BCA Assessment Report

8 Forest Road, Warriewood

Reference No: 114511-BCA-r2

Date: 7 July 2022

3.5. Public corridors in Class 2 and 3 Buildings – Clause C2.14

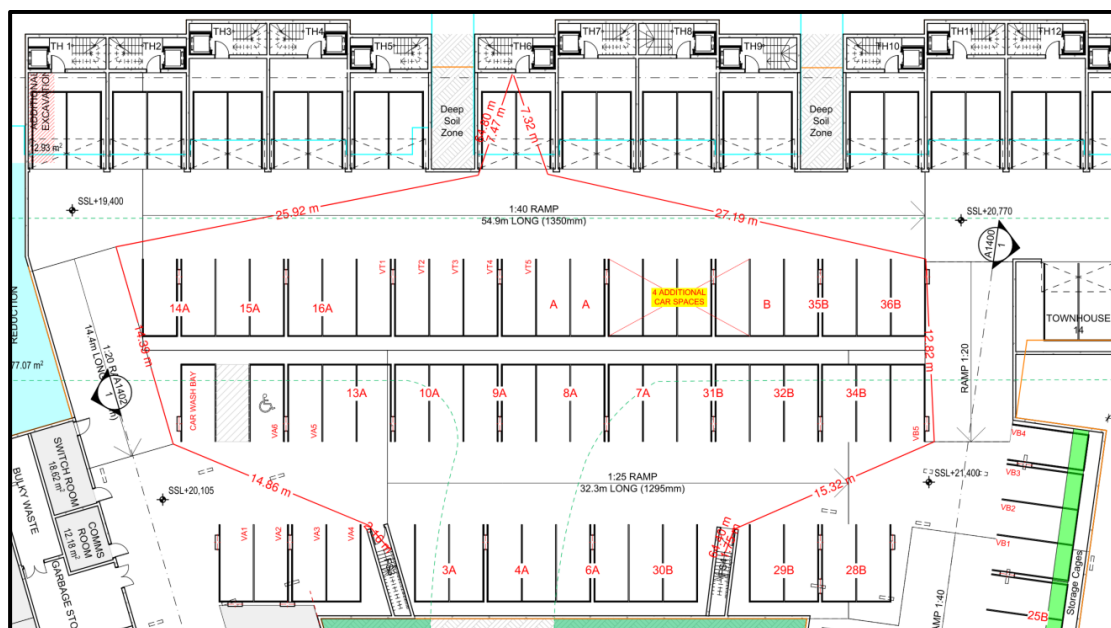
It is noted that Building D on the Ground Floor is found to have a corridor exceeding 40m in length and would need to be separated with a smoke wall to comply with this Clause.

In accordance with Clause D1.9 it is required to smoke separate the Ground Floor for the non-fire isolated stairways. Therefore, it is considered that compliance would be achieved once this occurs.

3.7. Distance between alternative exits – Clause D1.5

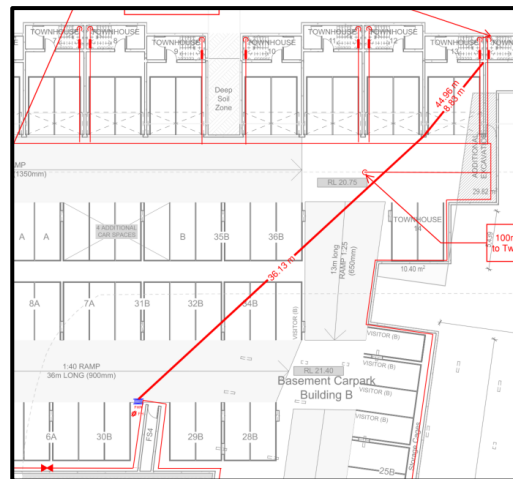
Throughout the residential storeys, it is noted that distance between the alternative exits would be sufficient, however it is noted that the basement will maintain a distance of up to 118m between alternative exits and would not comply with this Clause.

It would be required to introduce an additional egress path from this portion of the basement as egress via the SOUs is not a DTS provision. This may be provided by introducing a new egress stairway or allowing for a communication stairway being provided centrally between the two levels to allow for a short cut through the carparking in lieu of running around to the ramps.
